## ADDENDUM NO. 1

Board of Education – New Parking Lot

San Bernardino City Unified School District

RCA Project No. 1-78-60

## BOARD OF EDUCATION - NEW PARKING LOT

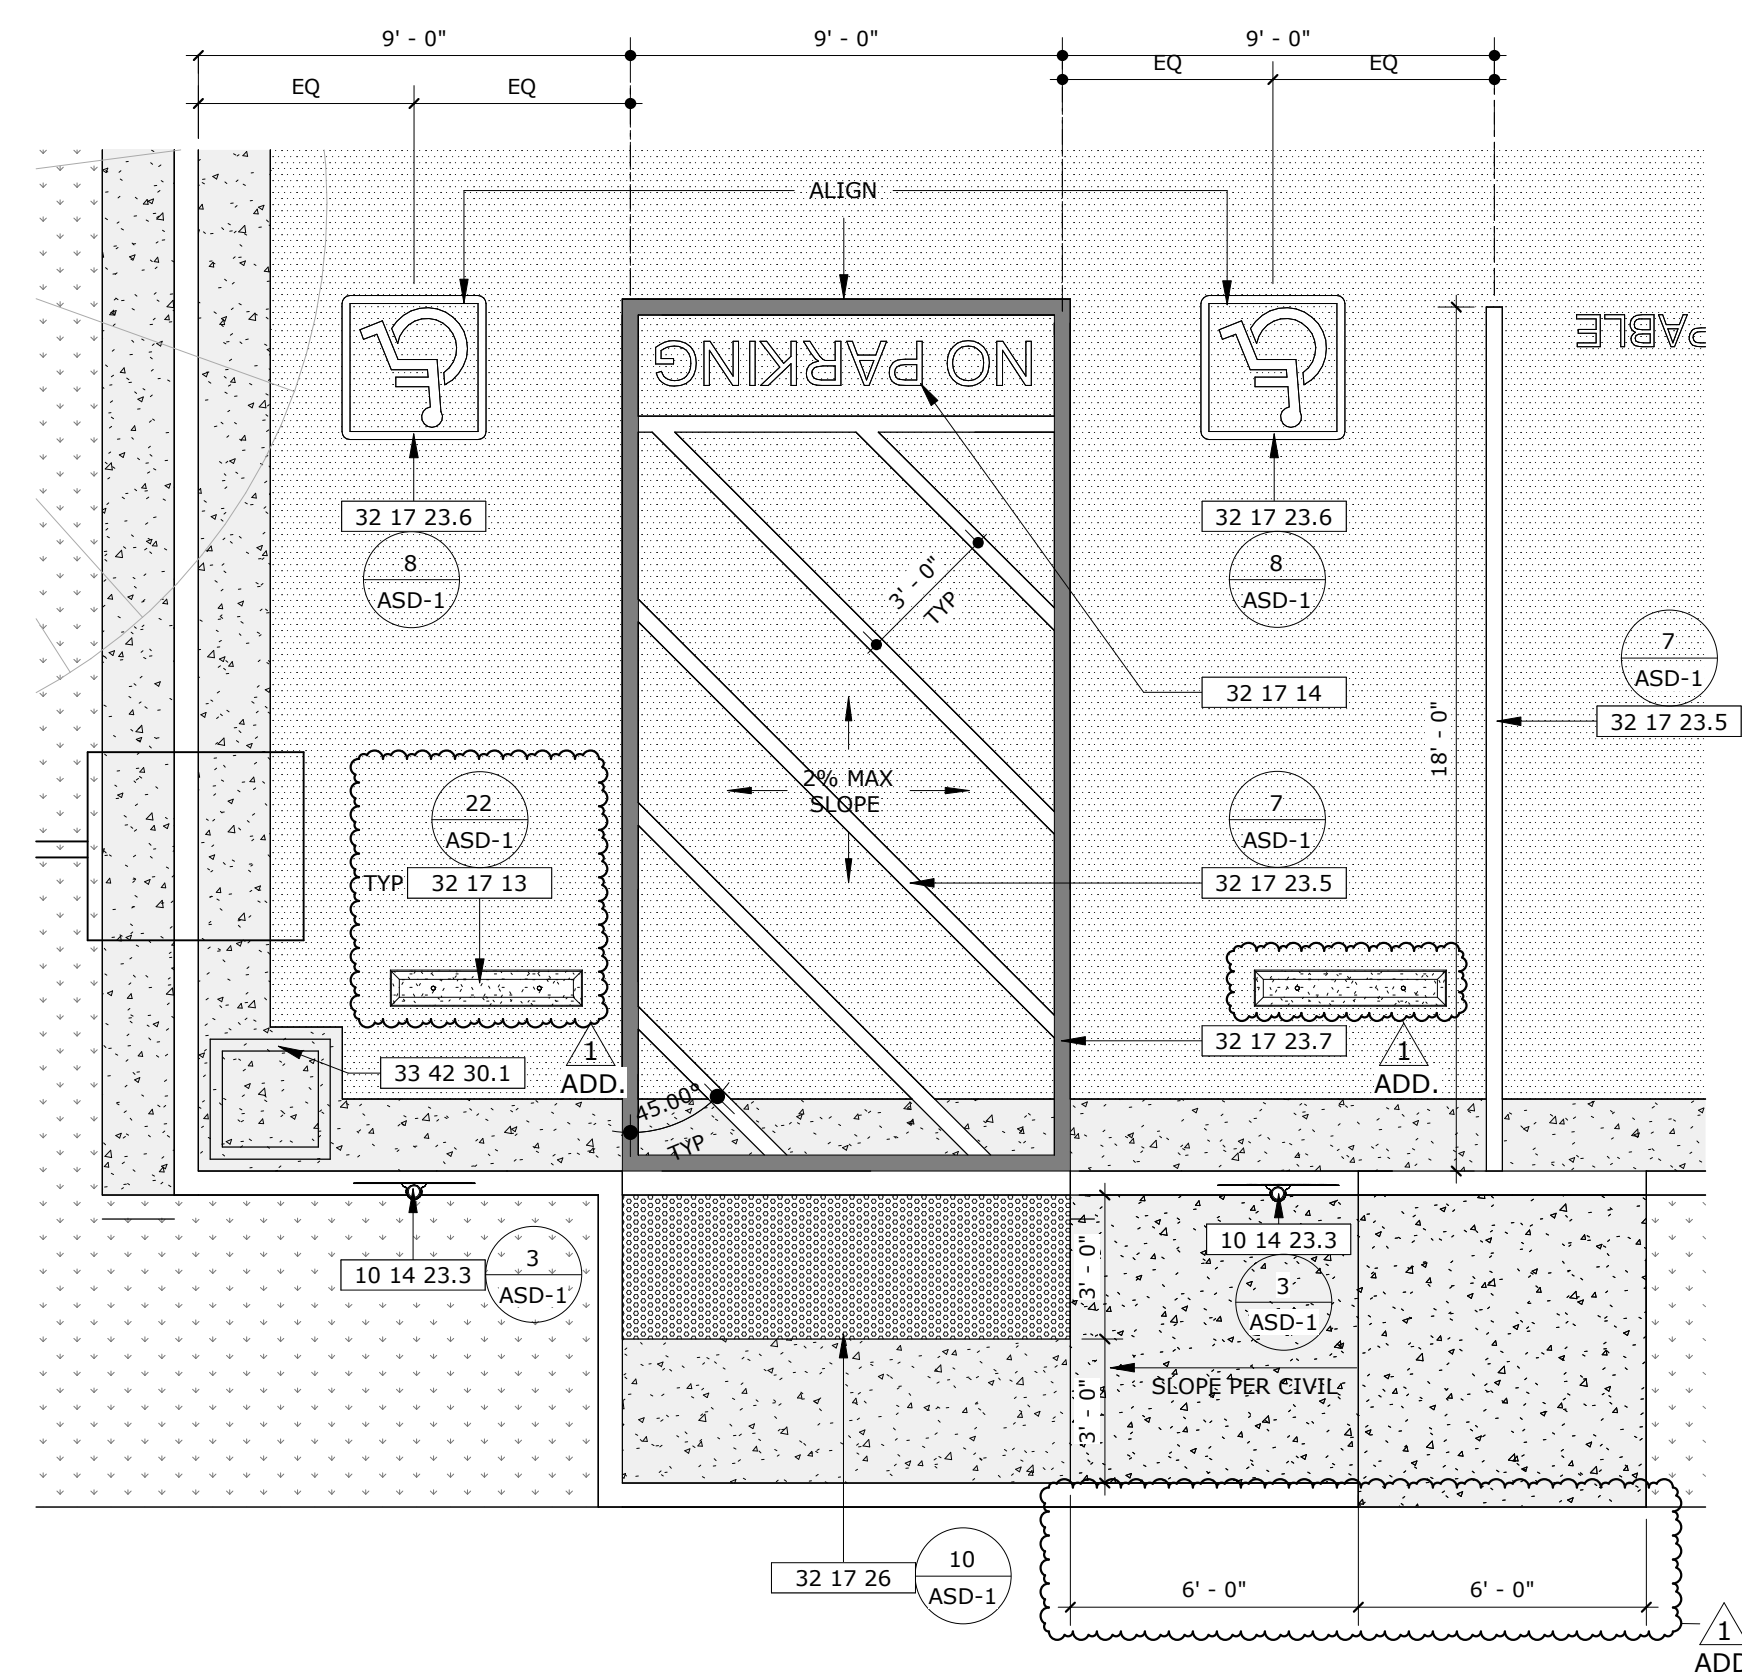
Item No. 1.11     Reference Sheet AS-2.0 – OVERALL SITE PLAN  
                   1.11.1    Replace Sheet AS-12.0 and revise per clouded areas listed below:  
                           (a)    Updated per landscape plan.  
                           (b)    Added wheel stops as shown.  
                           (c)    Provided additional dimensions for clarity.  
                           (d)    Removed text markings for EV capable stalls.

E-0.1

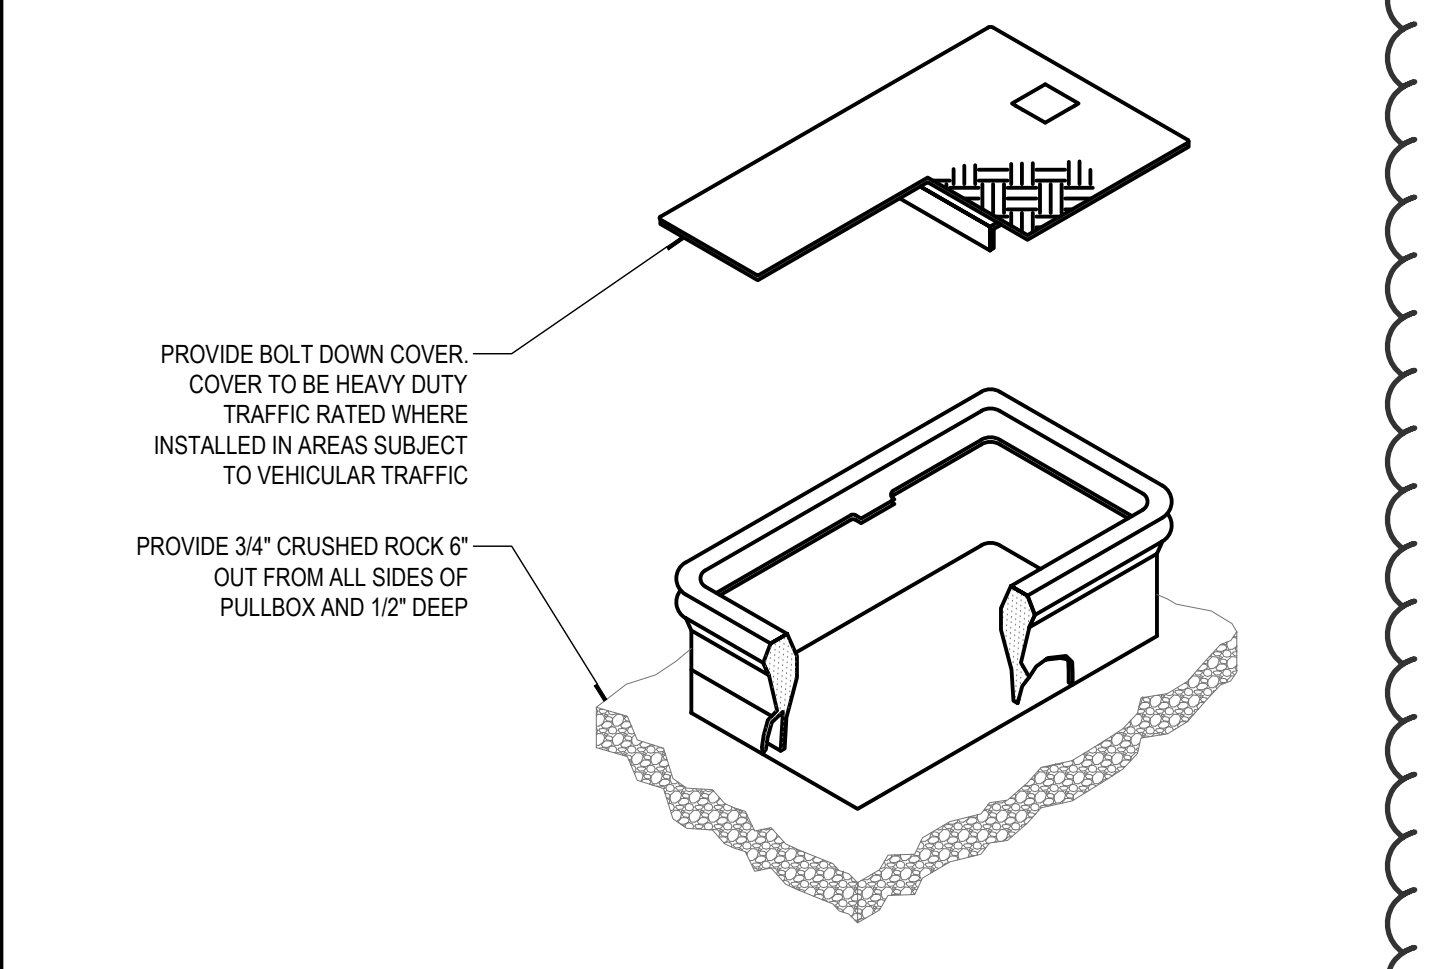
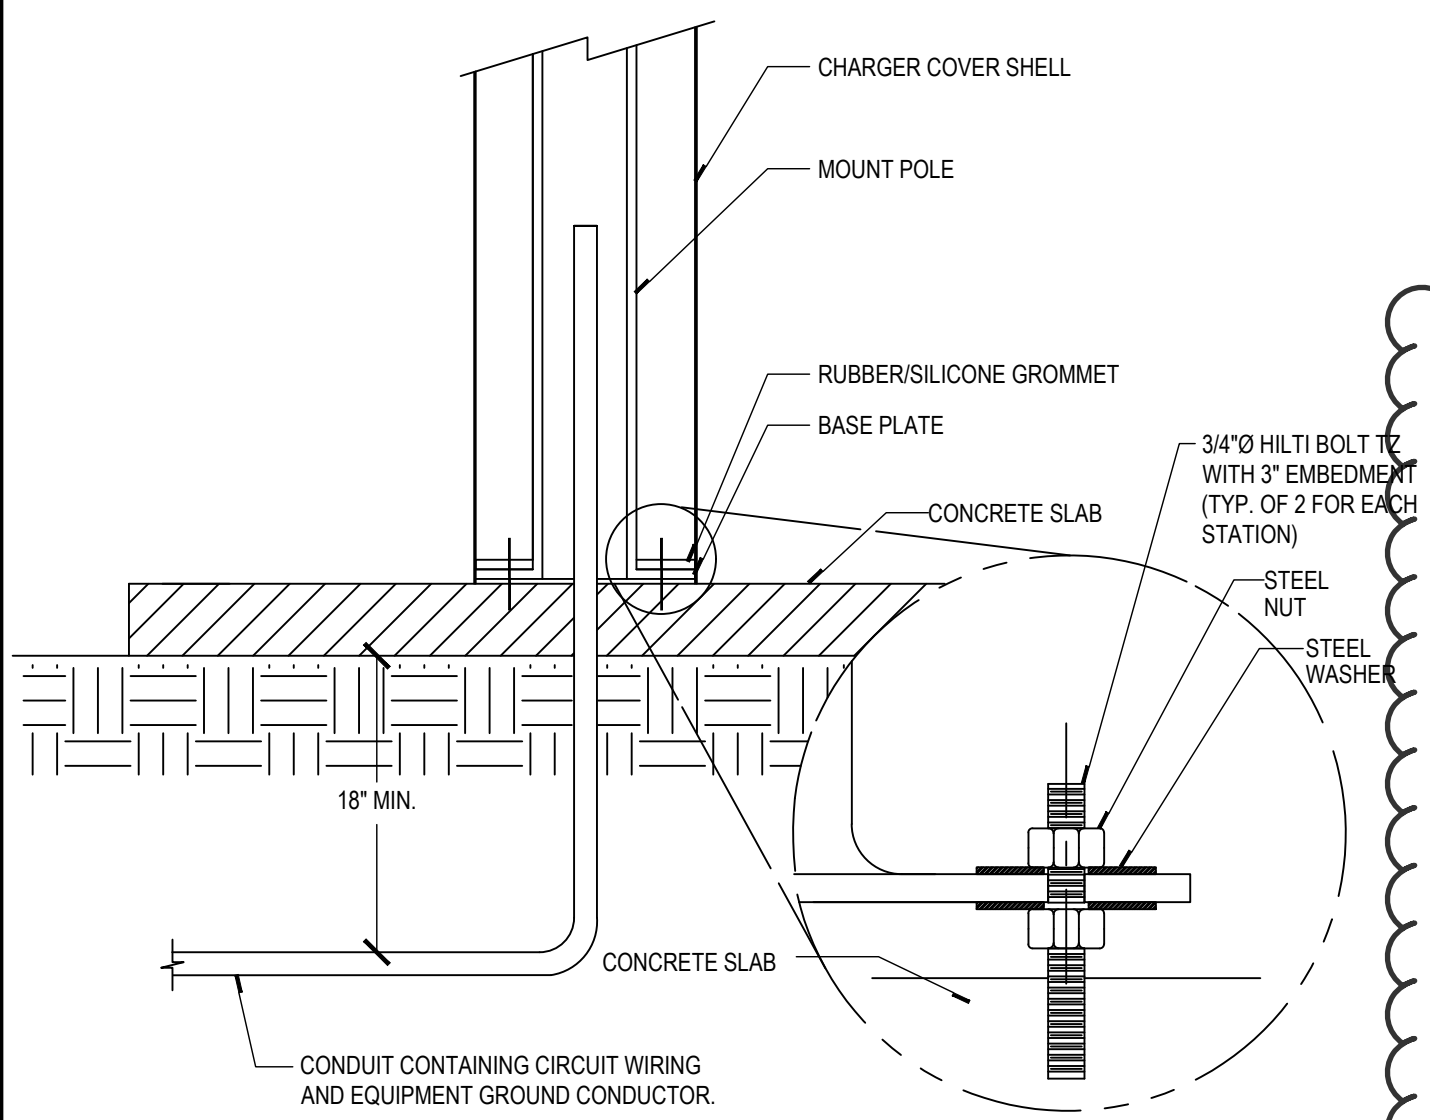
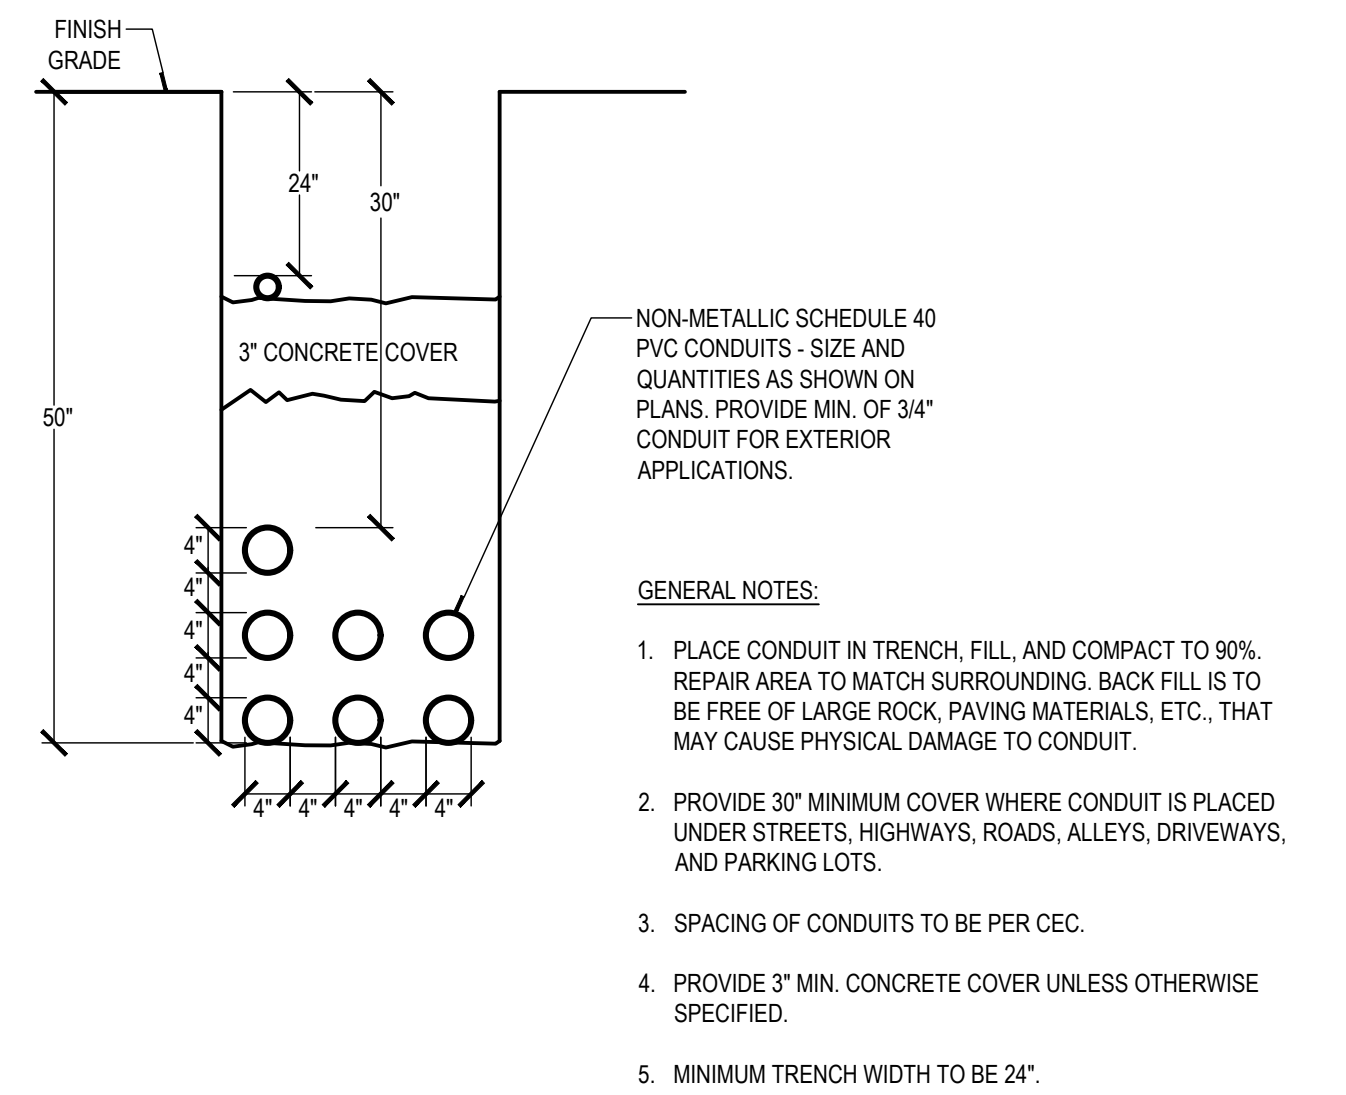
Item No. 1.13     Reference Sheet E-0.1 – ELECTRICAL LEGENDS, NOTES AND DETAILS  
                   1.13.1    Replace Sheet E-0.1 and revise per clouded areas listed below:  
                           (a)    Revised detail 2/-.

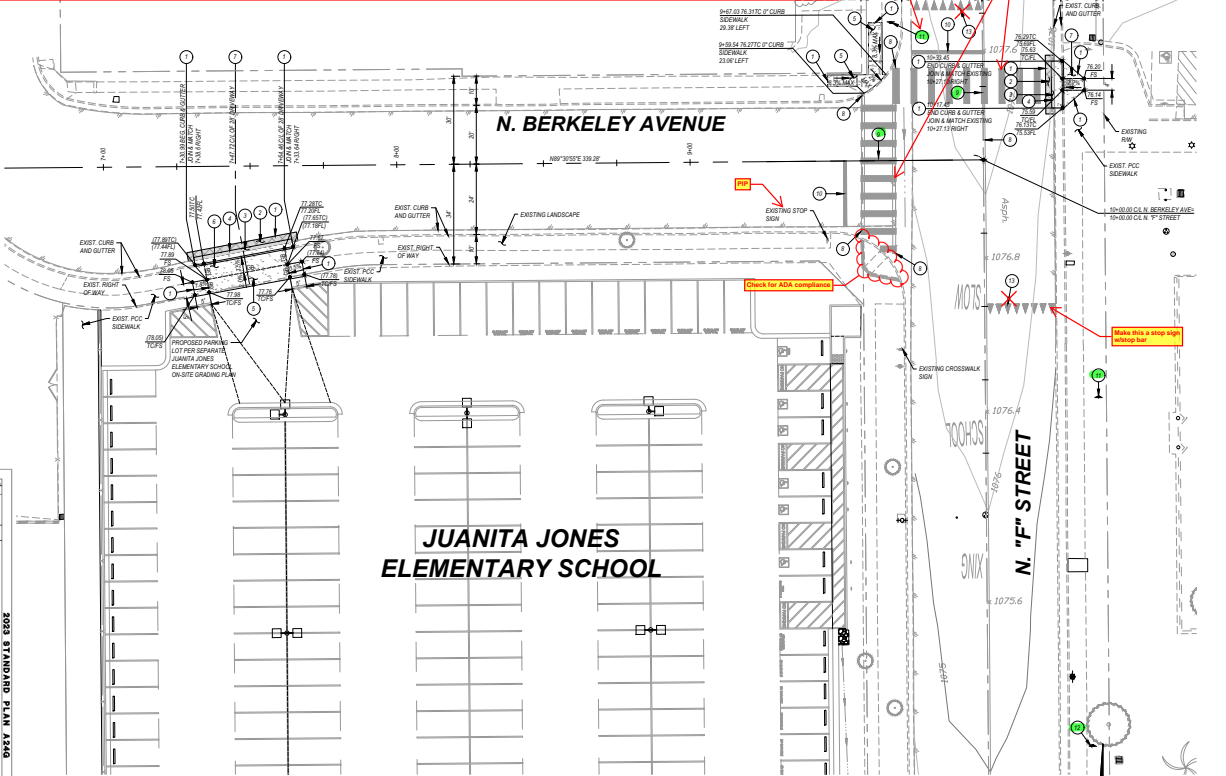
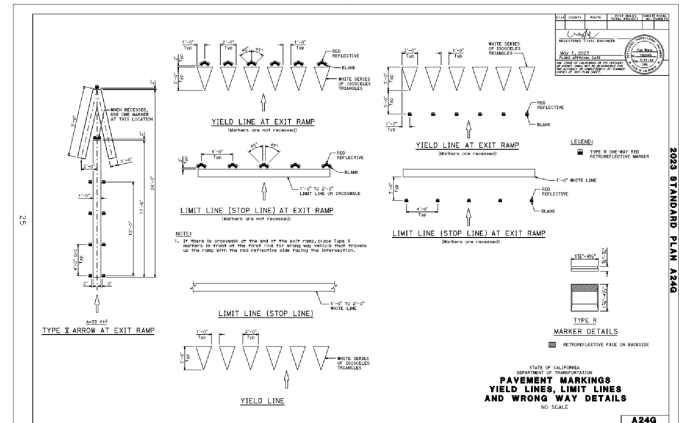
Per the direction of the City Engineer, please revise the Street Plans (E2400061) portion of the Juanita Jones Elementary Parking Lot to include the following:

- As discussed in our meeting on Tuesday, you agreed to construct an ADA compliant handicamp ramp at the northwest corner of F Street and Berkeley Avenue. Along with this ADA ramp, as previously already designed, keep the ramp across the street on the eastside of F Street.
- Install a stop sign with a **marked crosswalk** and **all the advance signage for stop-controlled intersection** (3-way Stop at the "T" intersection) at F Street and Berkeley Avenue.
- ~~Install the Rectangular Rapid Flashing Beacon previously planned for F Street and Berkeley Avenue at F Street and 7th Street where there is an existing marked cross-walk.~~

Aspen to sand example of preferred crosswalk

Modify appropriately

Mark this sheet as "For reference only" if it is reissued.

Add a new sheet for Signing & Striping

Item No. 1.14     Reference Exhibit Sheet C-6.2  
                   1.14.1    Add offsite scope described in attached exhibit to overall project scope.
